Technical Memorandum 10.2

Assessment of Groundwater- Surface Water Interactions

**for the Regional Groundwater
Storage and Recovery Project
and San Francisco Groundwater
Supply Project**

Supplemental Explanation for Hydrographs - TM10.2

Figure 10.2-11a

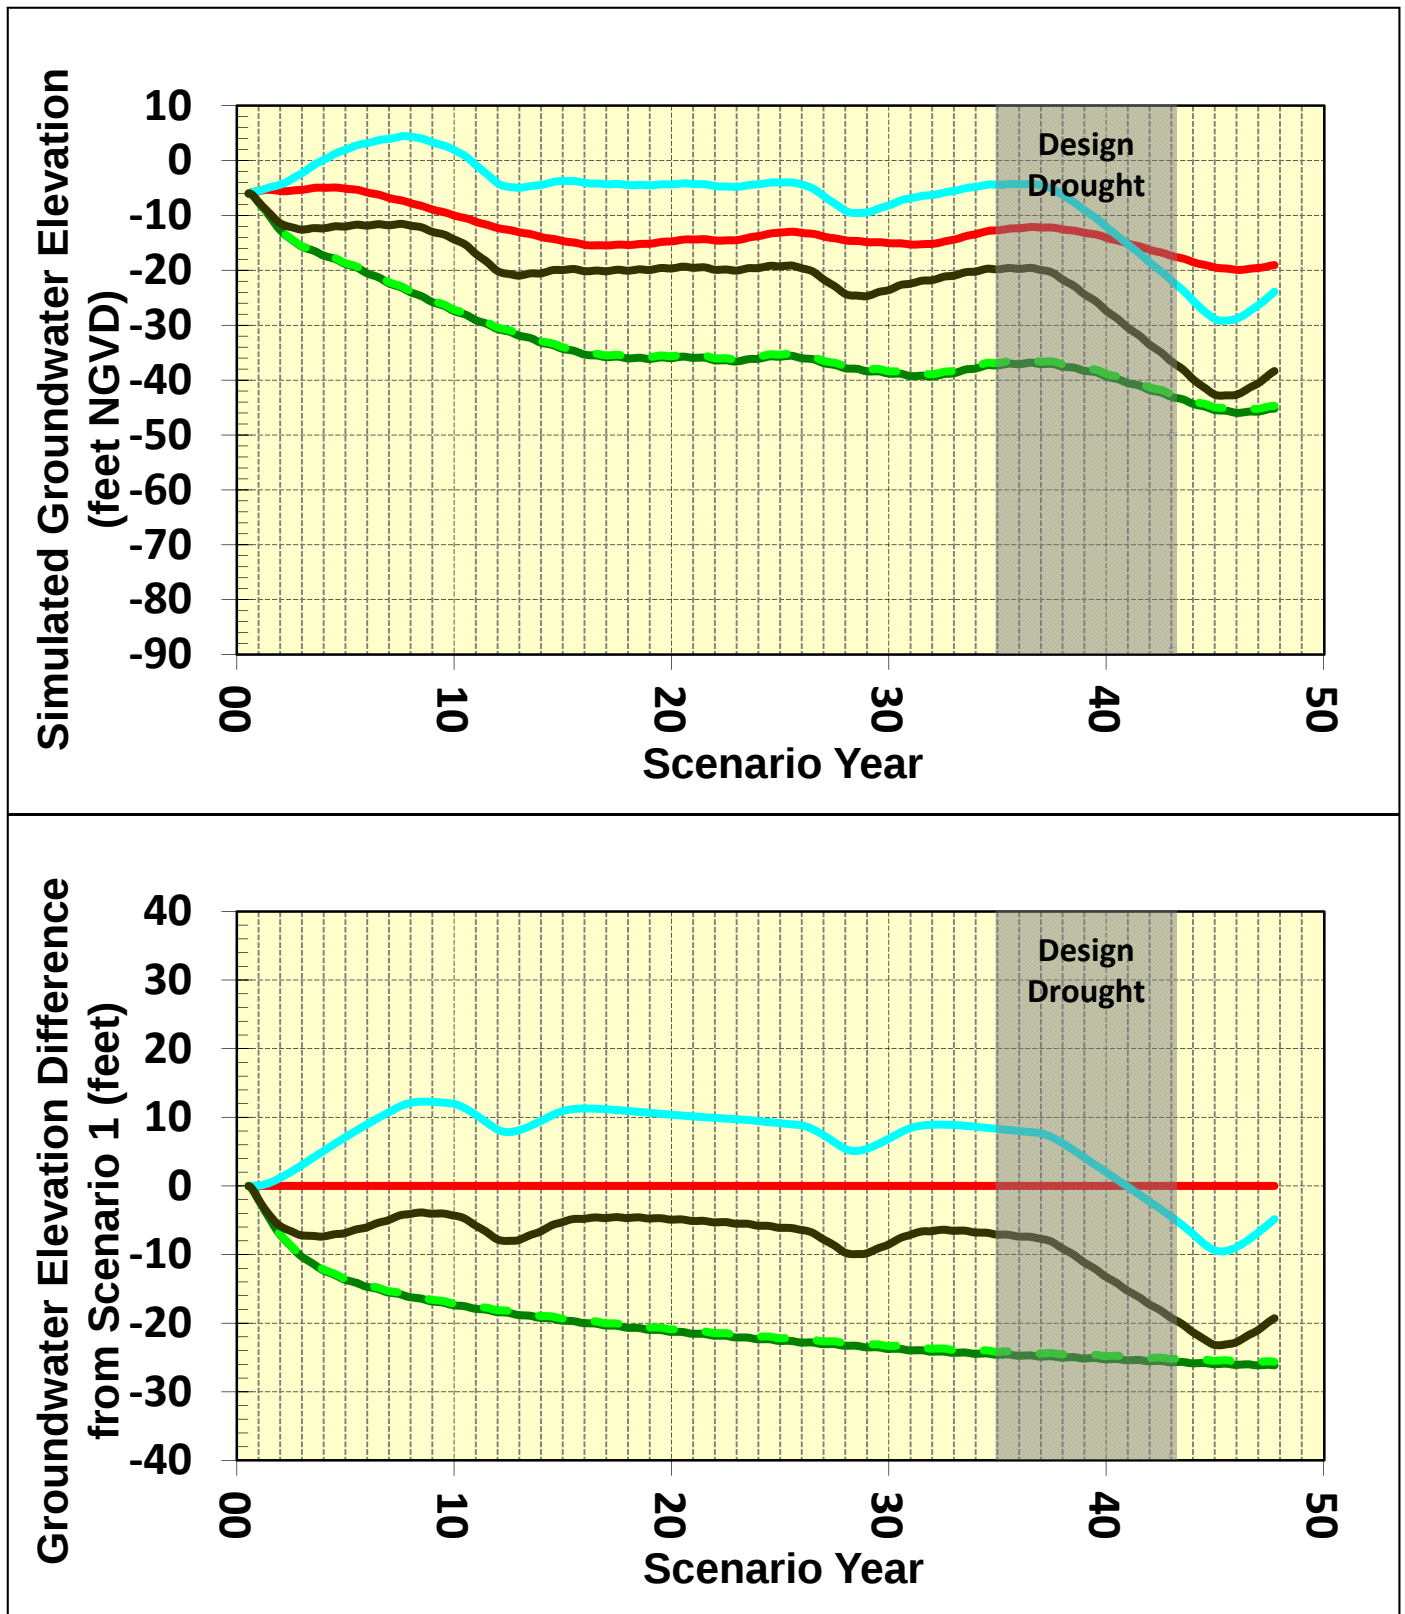
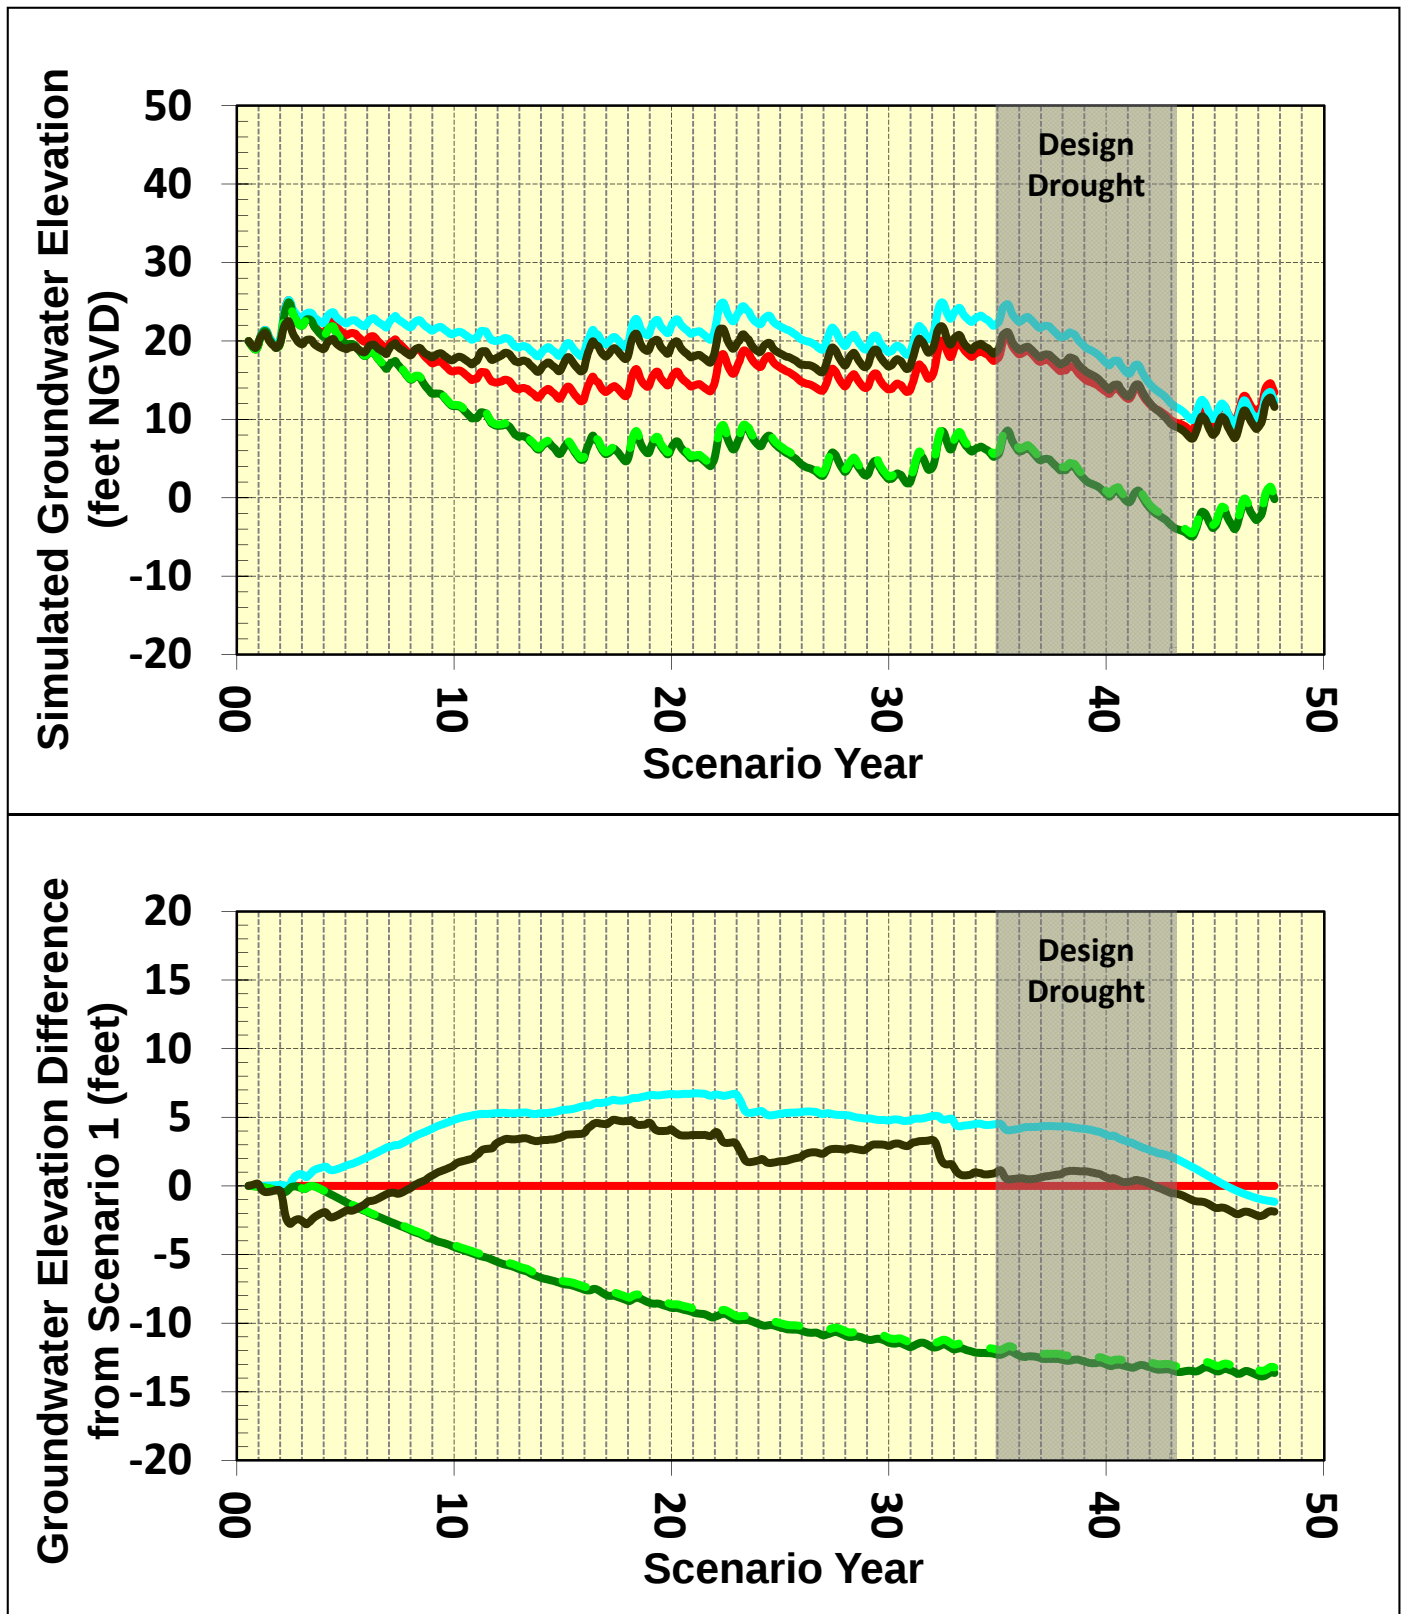
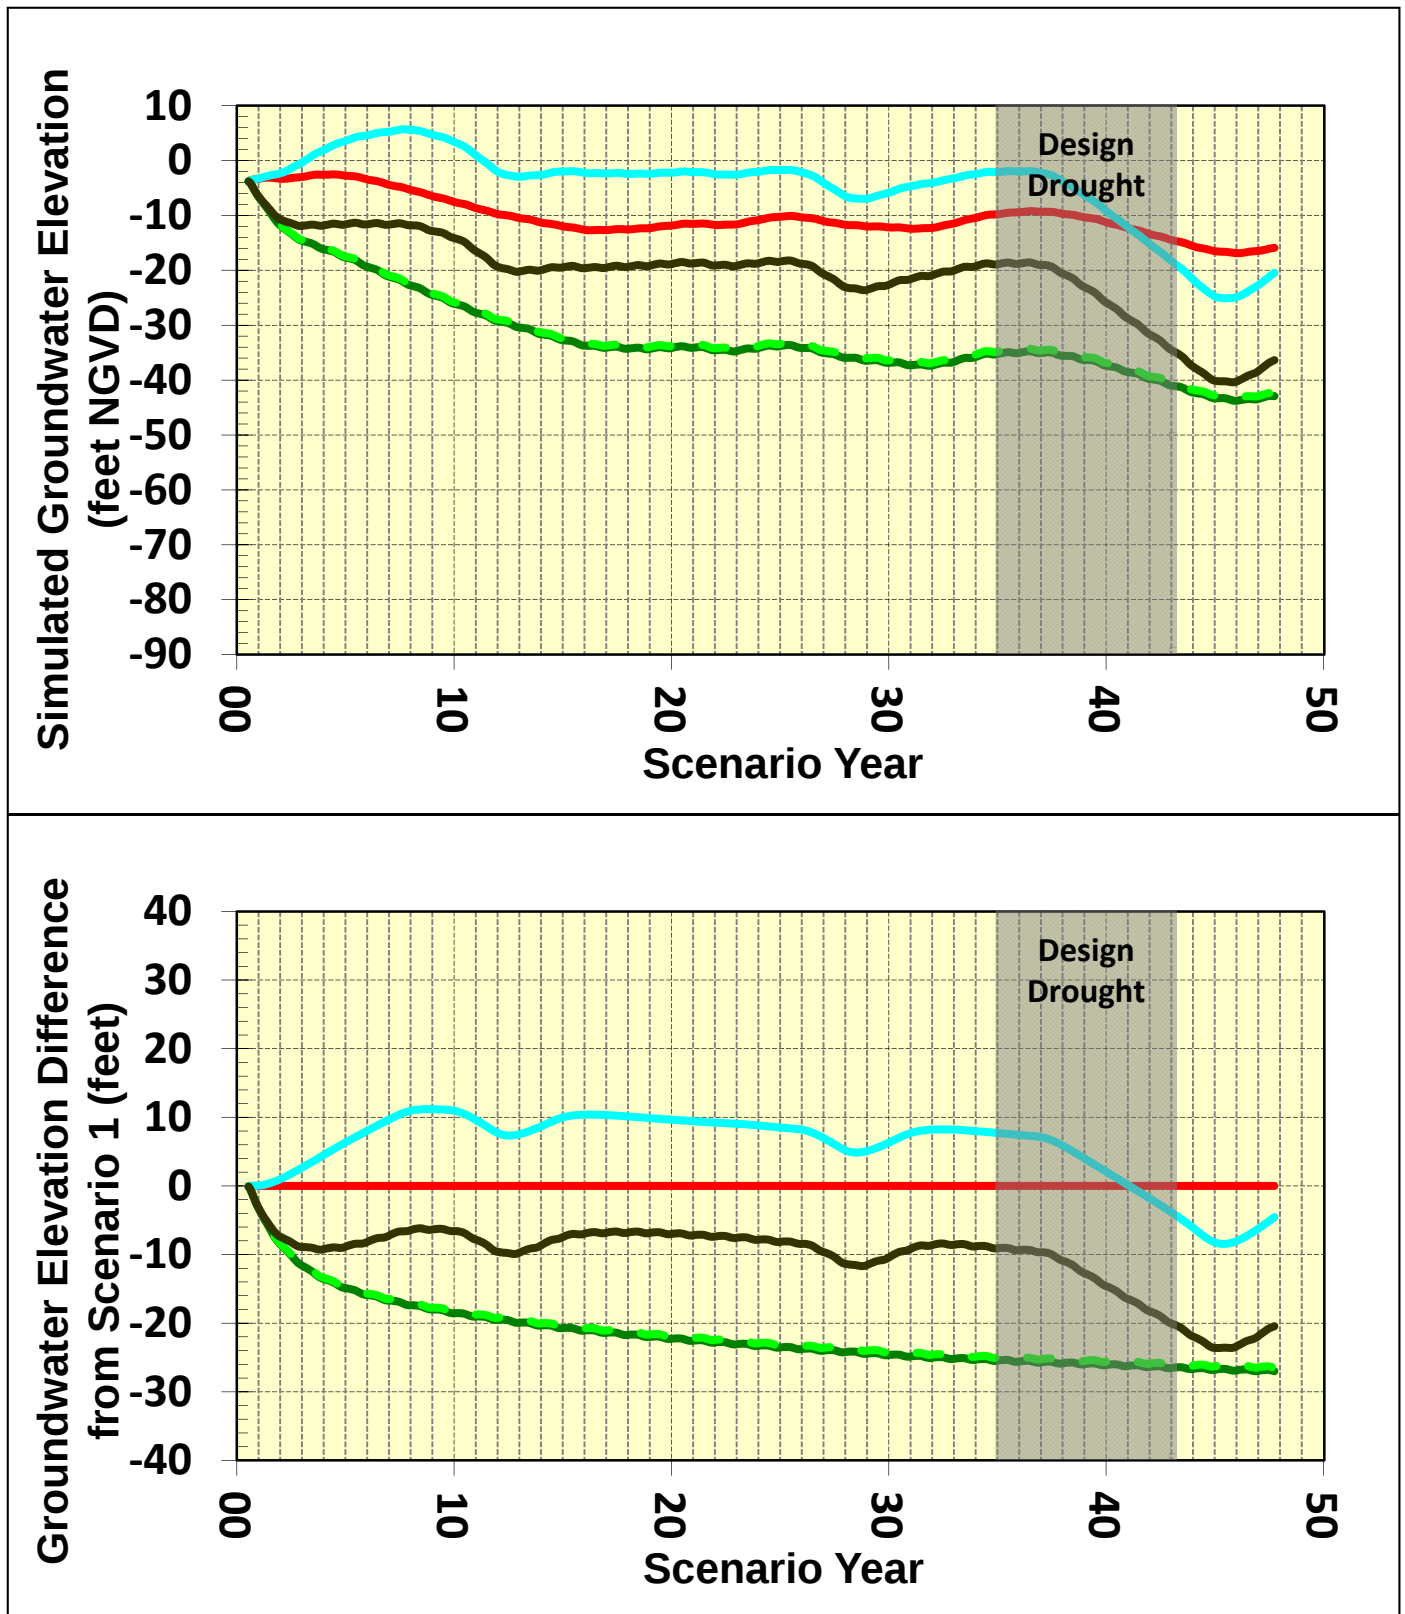
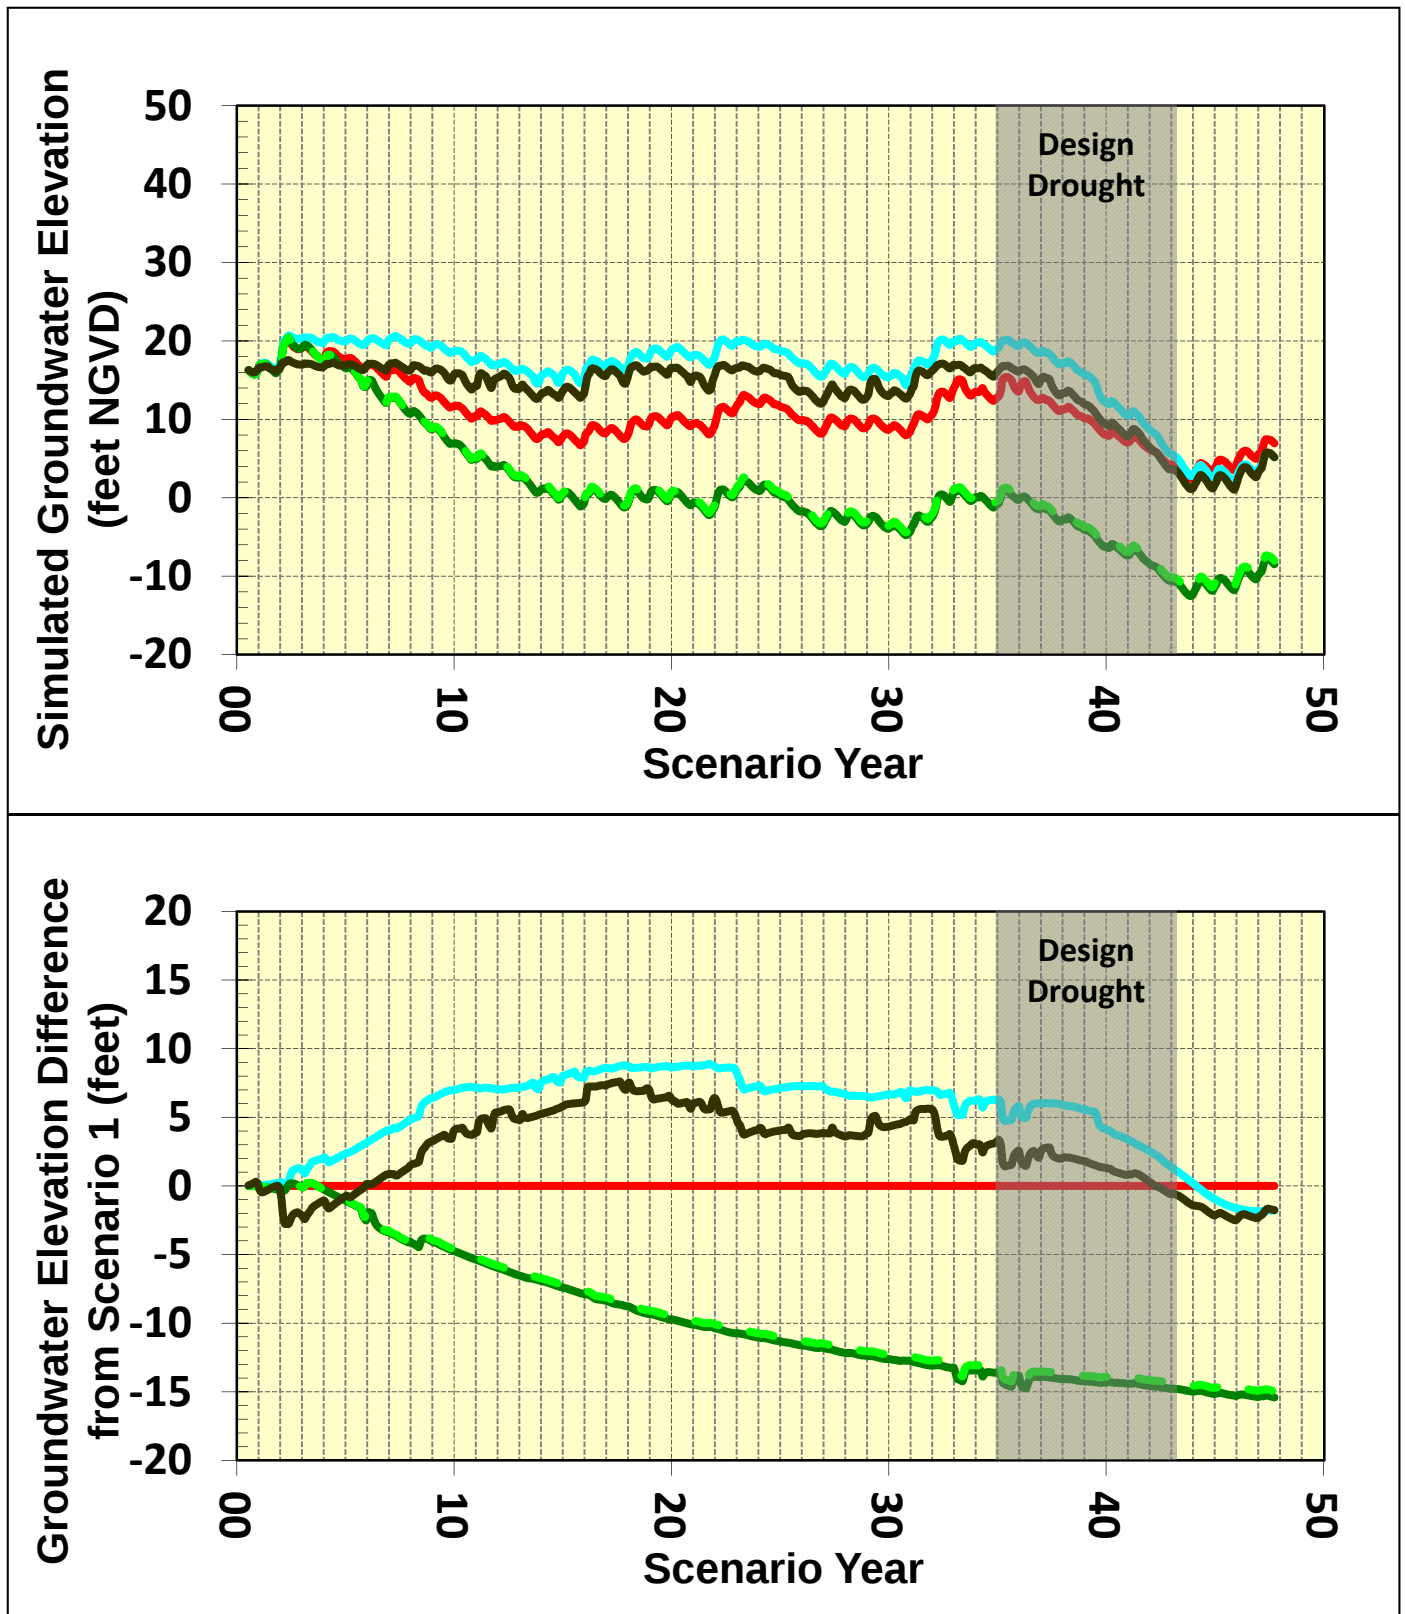
First, the x-axis on several graphs showing model results was shifted. The x-axis is named Scenario Year which should correspond to a water year¹. However, the graph template was plotted using a calendar year, so the intervals on the x-axis represent the period from January to December. The result is that the graph is shifted 3-months later relative to Scenario Year.

Second, the shaded area representing the Design Drought was added manually and because of this process, it was not presented consistently on the graphs. By definition per the PEIR, the 8.5-year Design Drought includes one Hold year before the 7.5-year Take period. In addition, the Design Drought needs to be shifted 3-months later for the x-axis issue to be consistent with the model output. The Design Drought should be shown as Scenario Years 35.5 to 44.0 on the shifted x-axis.

The following is a list of figures in TM 10.2 where the Design Drought shaded area is shown slightly different and does not match the correct display of the Design Drought. The figures should be viewed based on the correct representation of the Design Drought as explained above.

- o Figures 10.2-8 through 10.2-15 (a total of 13 figures) have the shifted x-axis. The Design Drought should be shown as Scenario Years 35.5 to 44.0 on the shifted x-axis.
